# Access Compliance Report

## Public Rights-of-Way

Intersection ID: 16930	Main Street: BUCKNELL_AV	Cross Street: ROSWELL_AV	Location:	N
ADA ID: 92102A05C558	Ramp Type: PerpDiag	Initial Pass/Fail: Fail	Overall Compliance: No	Severity Score: 21.25

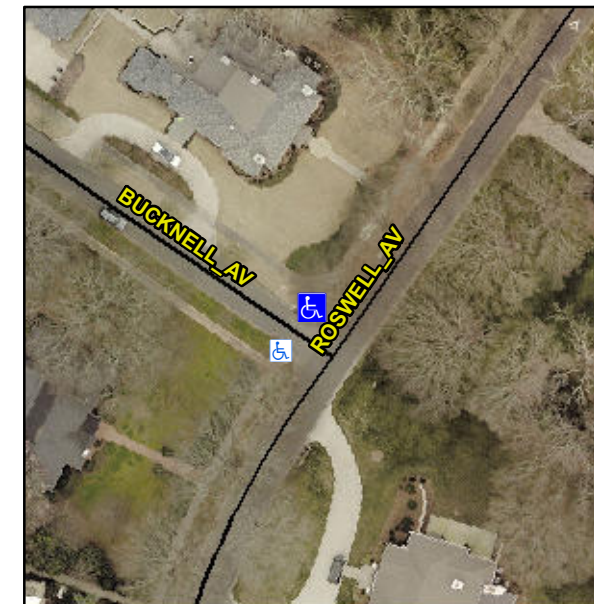
**Not Found, R304.5.1, R304.2.2**

Compliance	Description	Data	Compliance	Description	Data
N/A	Ramp Length (in)	102.0	No	Ramp Slope (%)	9.5
No	Ramp Width (in)	43.0	Yes	Ramp XSlope (%)	2.0
N/A	Flare Type LT	N/A	N/A	Flare Type RT	N/A
N/A	Flare Slope LT (%)	N/A	N/A	Flare Slope RT (%)	N/A
N/A	Flare Traversable LT?	N/A	N/A	Flare Traversable RT?	N/A
N/A	Landing Length (in)	N/A	N/A	DWS Provided?	N/A
N/A	Landing Width (in)	N/A	N/A	DWS Contrast?	N/A
N/A	Landing Slope (%)	N/A	N/A	DWS Length (in)	N/A
N/A	Landing X Slope (%)	N/A	N/A	DWS Full Width?	N/A
N/A	Landing Curb? (Y/N)	N/A	N/A	DWS Offset (in)	N/A
N/A	Shared Landing?	N/A			
N/A	Gutter Ponding?	Yes	N/A	Gutter Slope (%)	N/A
N/A	Gutter Lip Ht (in)	N/A	N/A	Gutter X Slope (%)	N/A
N/A	Painted X Walk1?	No	N/A	Painted X Walk2?	No
	X Walk 1 Direction	To SW		X Walk 2 Direction	To SE
N/A	X Walk 1 Width (in)	N/A	N/A	X Walk 2 Width (in)	N/A
	X Walk 1 Slope (%)	0.9		X Walk 2 Slope (%)	4.8
	X Walk 1 X Slope (%)	3.2		X Walk 2 X Slope (%)	2.0

**Remove & Replace Curb Ramp With Two New Directional Ramps or Equivalent.**
